03-3422 Arrangement of belt pulley/vibration damper

2nd version

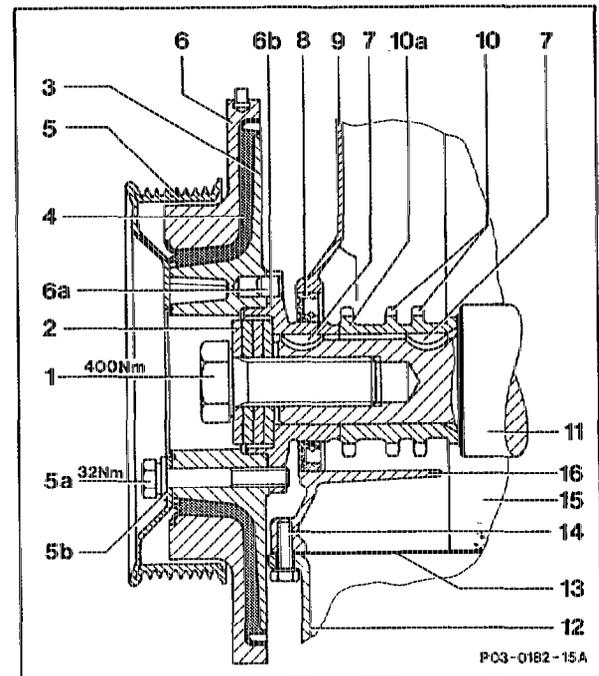
Arrangement of 8-groove belt pulley on primary side of vibration damper. Thus improving quiet running of poly V-belt.

3rd version

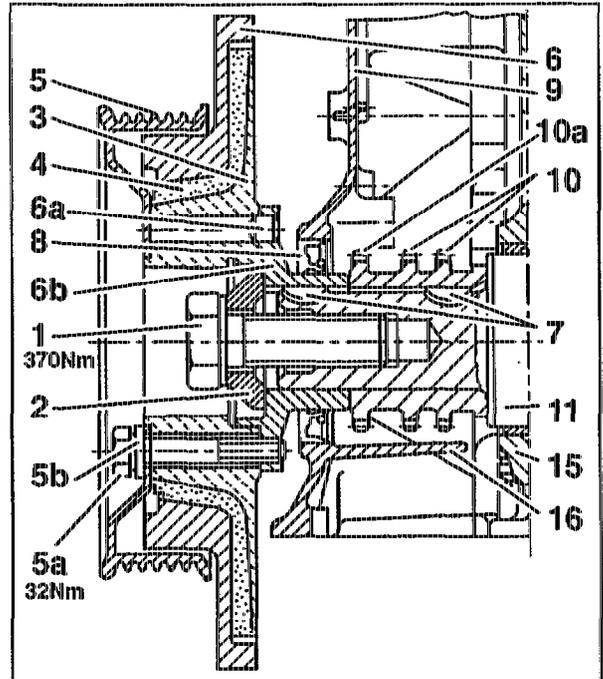
Modified central bolt.

Material strength modified from 10.9 to 8.8.

Conical washer replaces the 4 dished washers.

Modified tightening torque.

The different parts of the 3 versions must not be interchanged.

4th version

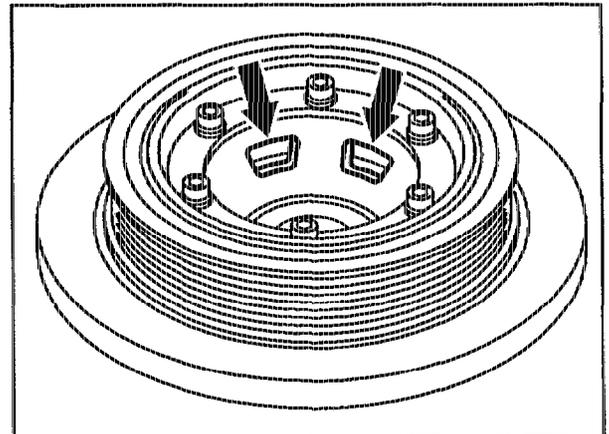
Belt pulley/vibration damper reduced in weight.

Hub integrated in vibration damper.
